Appendix H

Comments Received and Responses

U.S. Forest Service Comments on Draft Submittal

Kentucky Draft Regional Haze State Implementation Plan (RH SIP) - Specific Comments

Figure 1. IMPROVE monitoring data from stations at Mammoth Cave National Park and nearby USFS Class I areas (Linville Gorge and Shining Rock Wilderness Areas) showing light extinction from ammonium nitrate (data retrieved from: <https://views.cira.colostate.edu/fed/>).

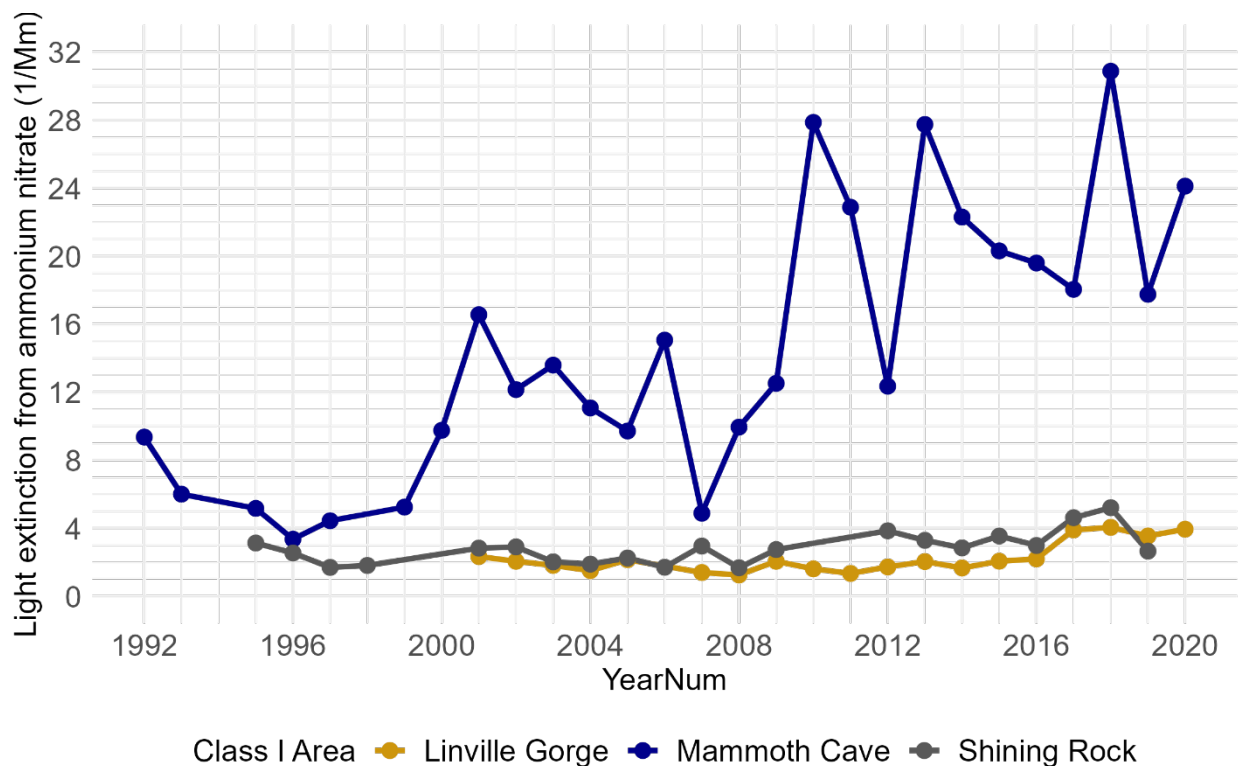
The draft RH SIP only evaluates SO₂ emission sources for reasonable progress evaluations / four-factor analyses. USDA Forest Service appreciates the discussion within the draft RH SIP regarding nitrate formation in the VISTAS region. We understand that nitrate formation in the VISTAS region is limited by the availability of ammonia (which preferentially reacts with SO₂ and sulfates before reacting with NO_x) and by temperature, with particulate nitrate concentrations highest in the winter months. We also recognize that sulfates have been the main contributor to visibility impairment at Class I Areas within the southern US. The emissions data show that most NO_x emissions within KY are from the mobile sector, however Electrical Generating Units (EGUs) are the second highest sector. Additionally, the nitrate contribution to visibility impairment is increasing as sulfur dioxide emissions decrease, and there are still significant NO_x sources within the point sector in KY. IMPROVE monitoring data from Mammoth Cave National Park and nearby USFS Class I areas in NC (Shining Rock and Linville Gorge Wilderness Areas) show that some of the highest rates of light extinction from ammonium nitrate have occurred within the last several years (Figure 1). EPA's 2019 Regional Haze Guidance states that "because regional haze results from a multitude of sources over a broad geographic area, a measure may be necessary for reasonable progress even if that measure in isolation does not result in perceptible visibility improvement." Widespread emissions controls, particularly for SO₂ and NO_x, are essential for making

reasonable progress at Class I areas both near to, and more distant from, emissions sources. Further, small visibility improvements, even those that may be imperceptible by themselves, are essential as we continue to make progress towards the national goal of restoring natural conditions at Class I areas by 2064. We request that KY consider evaluating NO_x sources, along with SO₂ sources, for reasonable progress during this planning period.

Figure 1: Ten-year trends in NO_x emission rates (lb/MMBtu, annual average) for the D.B. Wilson unit.

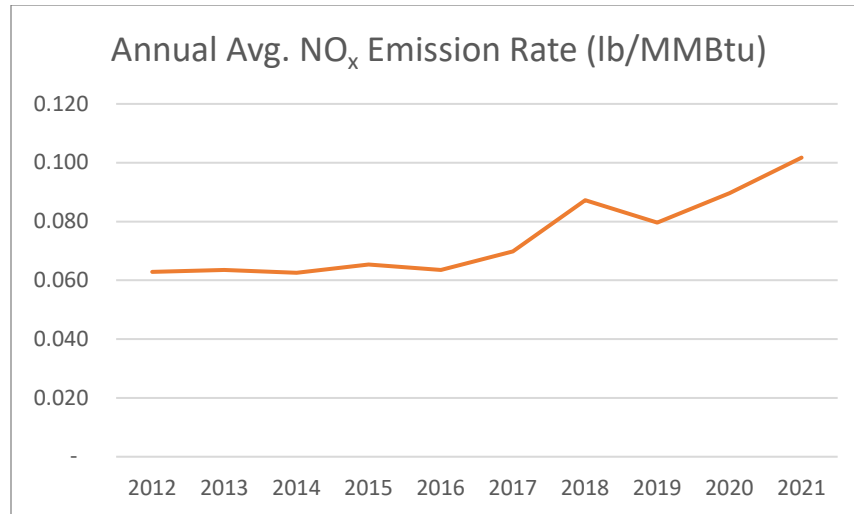
Based on CAMD data, the SCR unit on the D.B. Wilson boiler has been achieving a 0.086 lb/MMBtu NO_x emission rate (most recent 5-year average). However, the unit has operated at much lower NO_x rates in the past (below 0.08 lb/MMBtu). NO_x emissions rates have been steadily increasing above 0.08 lb/MMBtu since 2016 (see Figure 1).

The NPS recommends that the Kentucky address SCR optimization under the SIP to ensure the D.B. Wilson unit consistently achieves emission rates achieved between 2012 and 2016. (Requisite limits should be incorporated into the permit to ensure the SCR system achieves optimal NO_x emission rates.) This recommendation is consistent with the EPA clarification memo which states, it “*may be difficult for a state to demonstrate that a four-factor analysis is futile for a source just because it has an “effective control” if it has recently operated at a significantly lower emission rate.*” Finally, the NPS notes that upgrades may be necessary under the benchmark NO_x emission limits proposed in the “Good Neighbor” rule.

Figure 2: Shawnee Unit 1 SO₂ Emission Rate Trends (1997-2021)

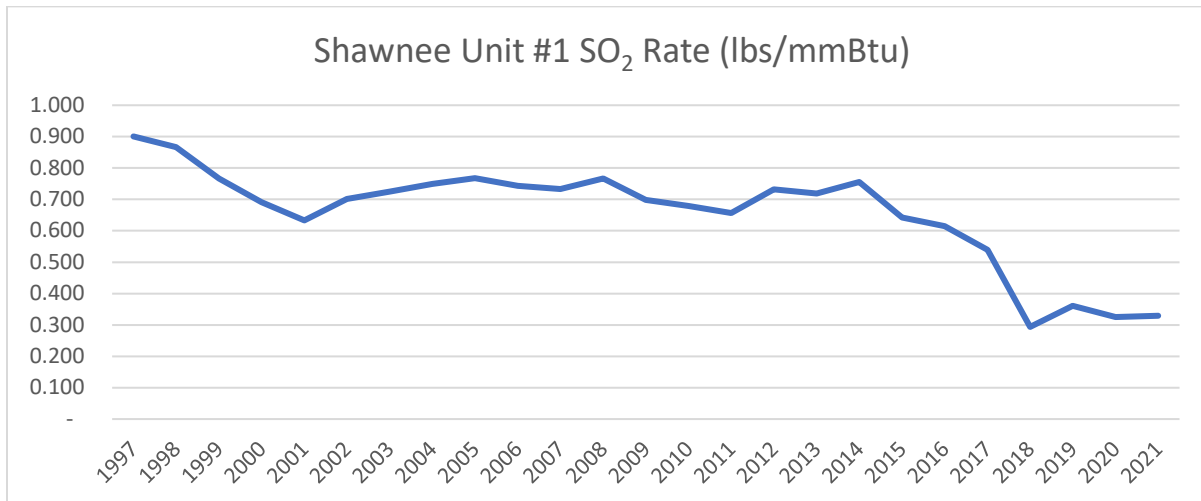
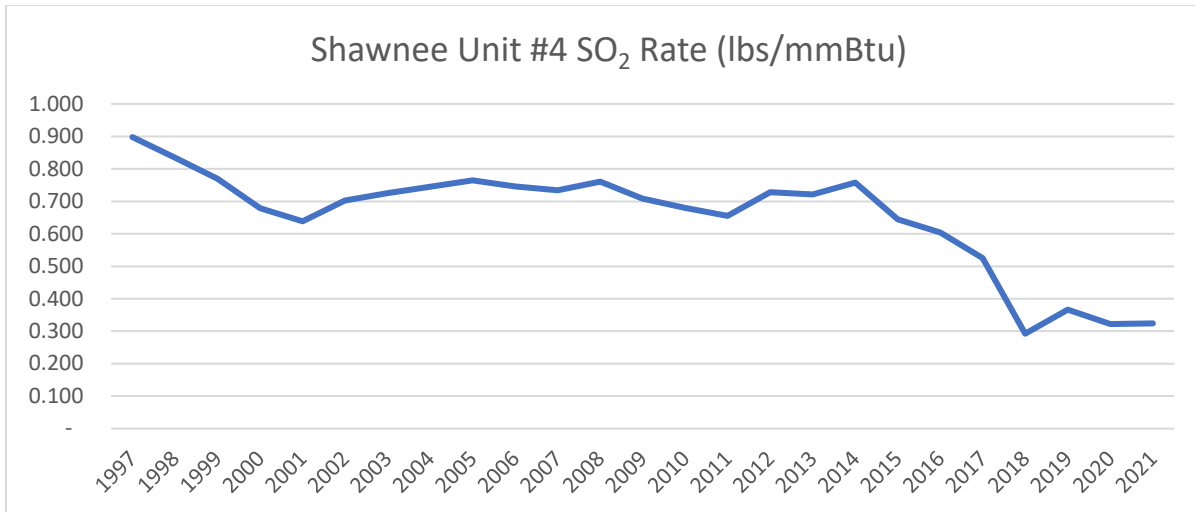
Shawnee Units 1 and 4 are equipped with a Dry Lime FGDs which began operating in November and October of 2017, respectively. Current control efficiencies were calculated using estimates of current uncontrolled emissions. Uncontrolled emissions were calculated based on EIA fuels data and AP-42 emission factors for uncontrolled SO₂ emissions from PRB coals and dry-bottom wall-fired units. Based on these estimates, the scrubbers on Units 1 and 4 have been achieving approximately 28%-29%²⁰ control efficiency over the past four years since the scrubbers were installed, which is very poor performance for relatively new scrubbers.

The NPS anticipates that a dry scrubbing system achieving 95% control efficiency would result in a 0.0227 lb/MMBtu emission rate based on the current calculated uncontrolled rates. When ranking all coal-fired units in the 2021 CAMD database from the tightest controlled to the least controlled on a lb/MMBtu basis, achieving an emission rate in this range would rank these Shawnee units #46. This is well within the range of achievable emission rates demonstrated in practice. The NPS recommends that Kentucky require evaluation and implementation of scrubber upgrades for Shawnee units 1 and 4.

Figure 4: Shawnee Unit 1 NO_x Emission Rate Trends (1997-2021)

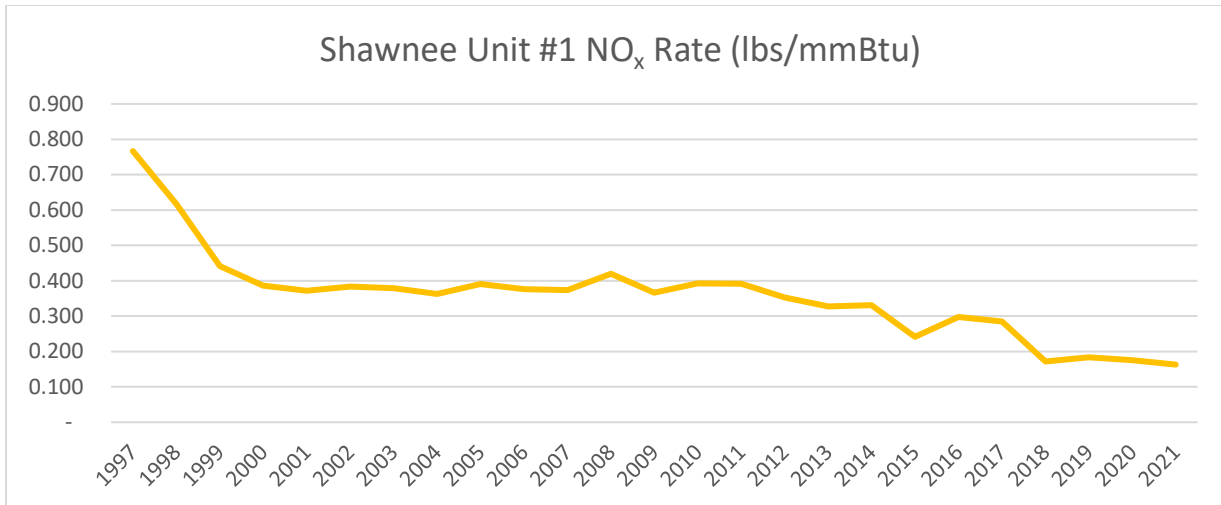
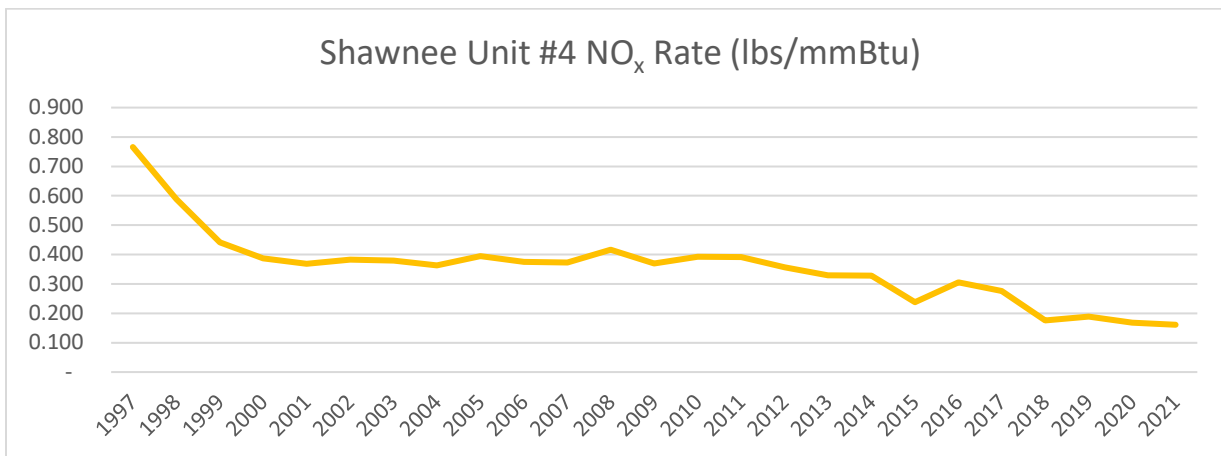
Shawnee Units 1 and 4 are equipped with LNB Technology (Dry Bottom only) and SCR. The SCRs began operating in November and October of 2017, respectively. Based on information provided in the CAMD database, the NPS estimates that the SCRs on these units have been achieving 45% control over the past four years which is poor performance for newer SCR units. The NPS recommends that Kentucky evaluate optimization of the SCR systems on Shawnee Units 1 and 4.

Figure 6: Mill Creek Unit 1 SO₂ Emission Rate Trends (2016-2021)

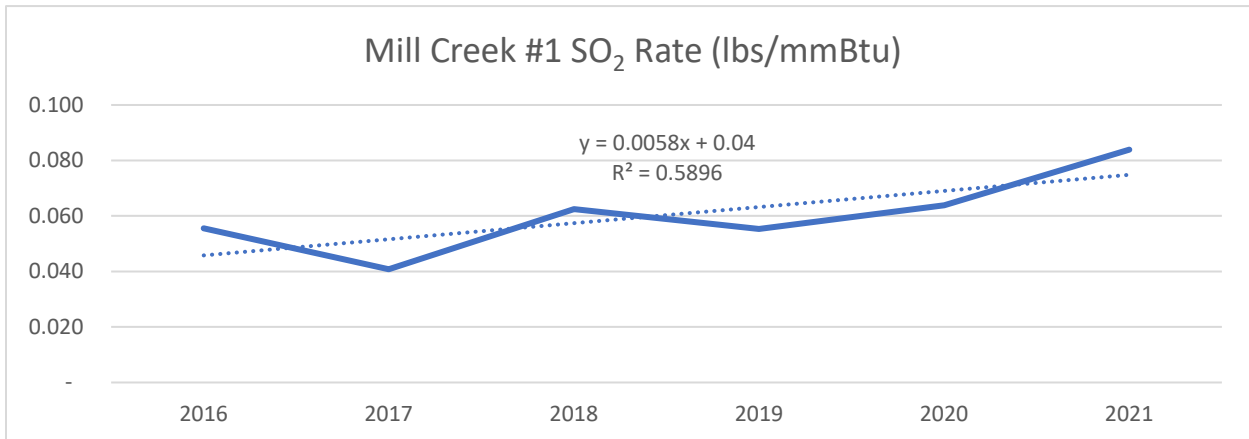
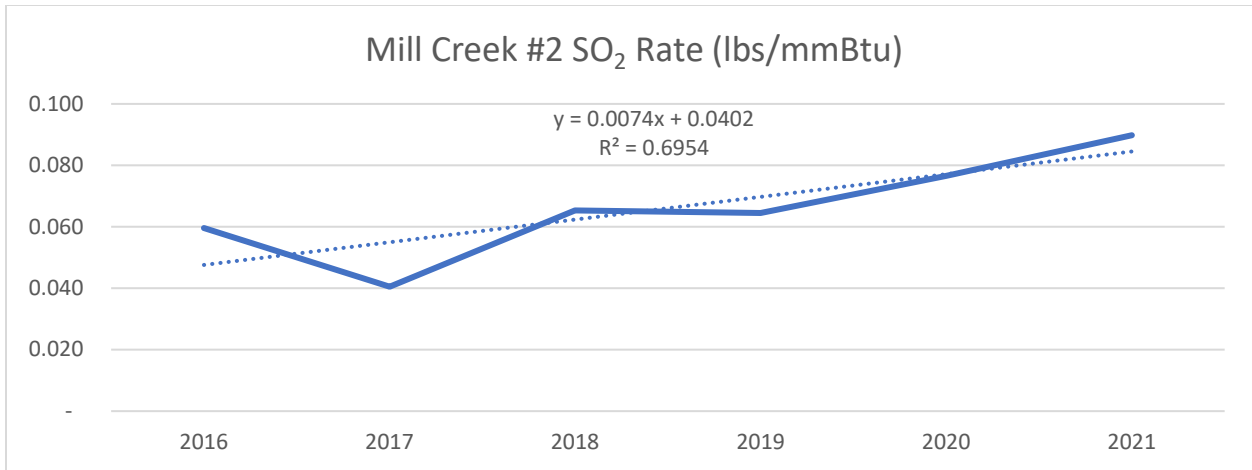
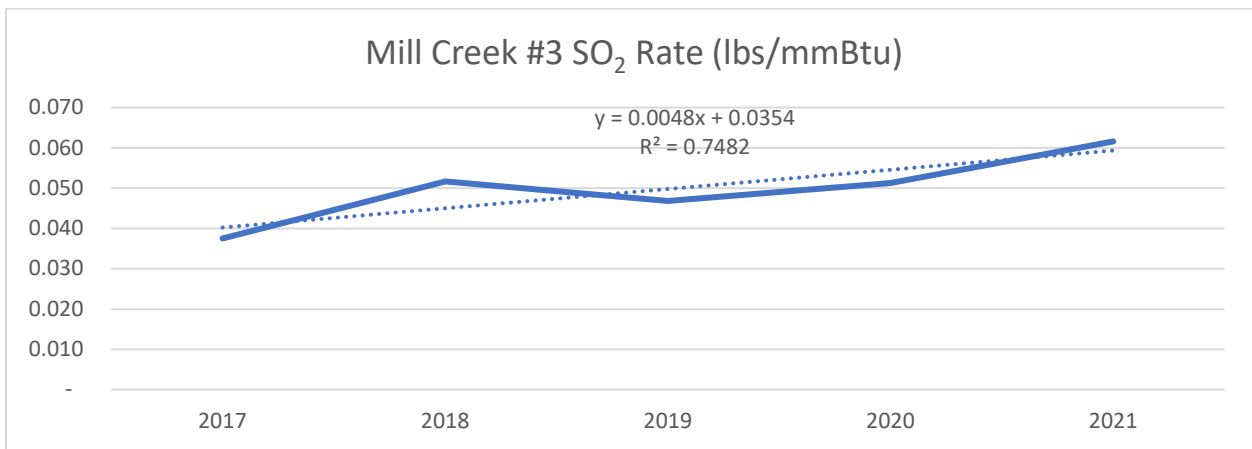
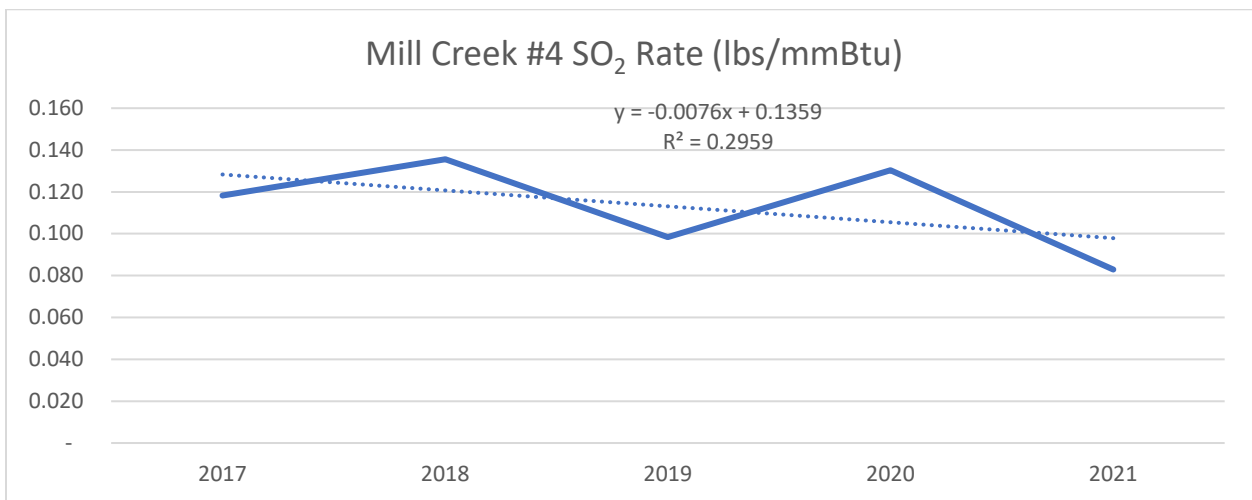
The following figures provide SO₂ emission rates for Mill Creek Station units 1-4. Even though the scrubbers on these units have averaged 98% to 99% control over the past five years, the charts indicate that scrubber performance on Units 1, 2 and 3 has deteriorated during this period and scrubber performance should be addressed. These recommendations are consistent with Section 2.3 of the July 2021 EPA Clarification Memorandum, which addressed the analytical expectations for “effectively controlled” determinations.

Figure 10: Ghent Station Unit 1 SO₂ Emission Rate Trends (2017-2021)

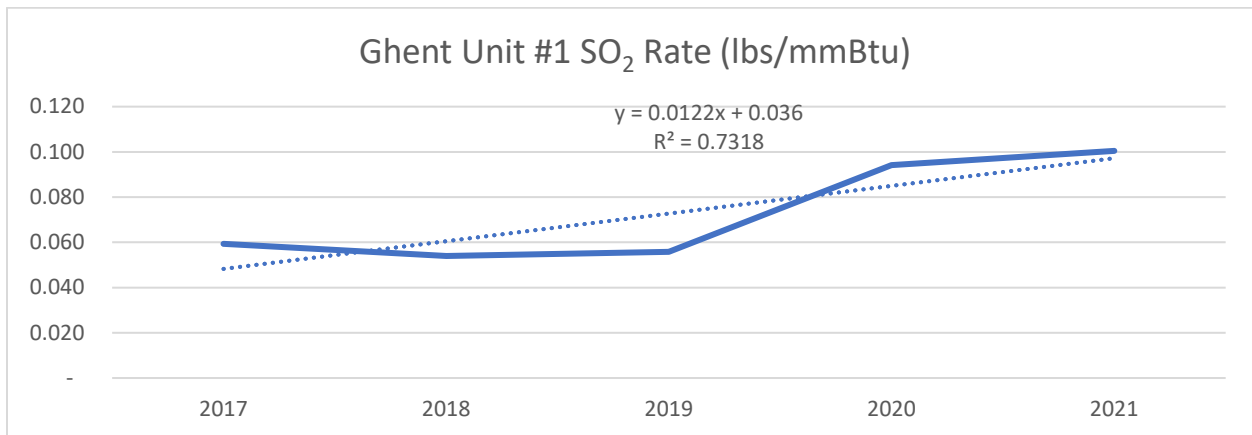
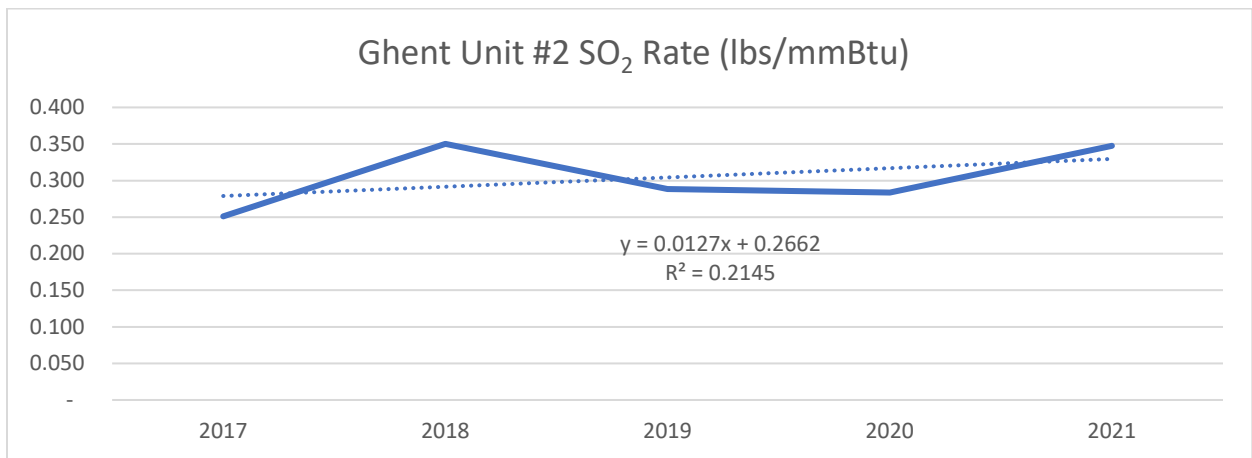
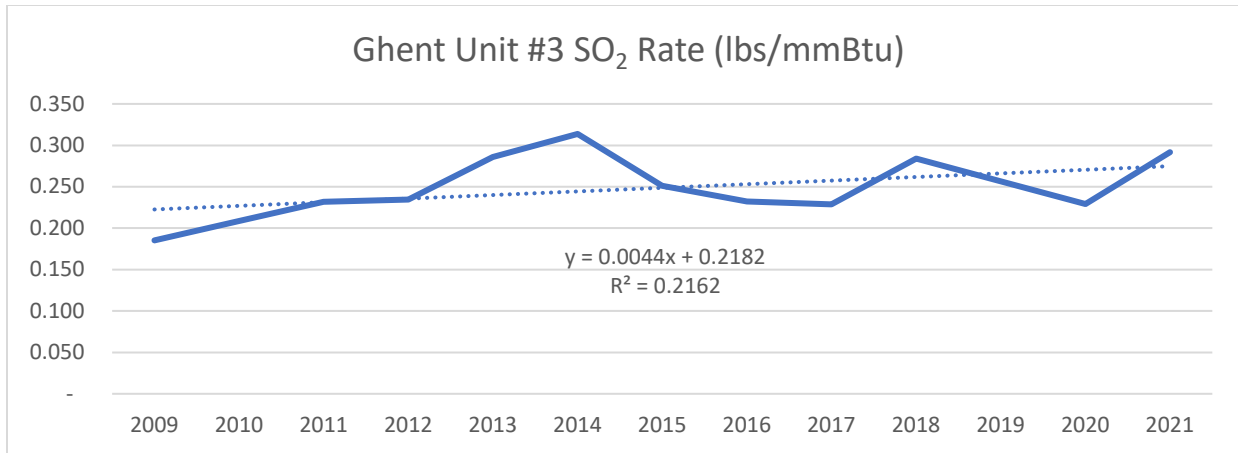
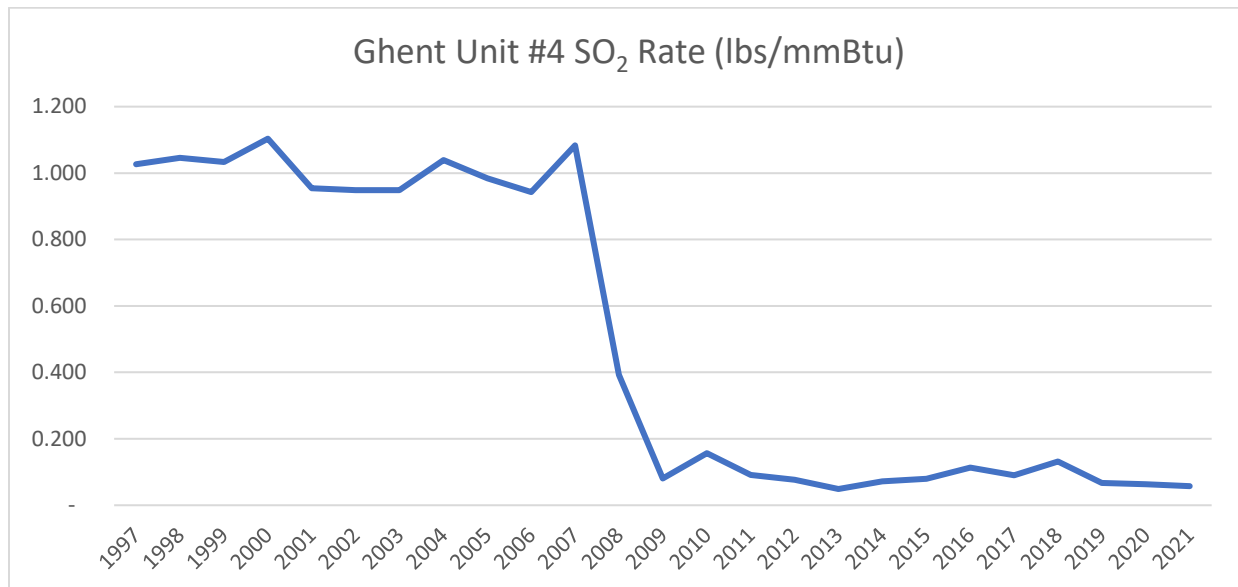
The following figures provide SO₂ emission rate trends Ghent Units 1-4.

Based on the unit-specific emission trends, the NPS recommends the following for the wet limestone scrubbers:
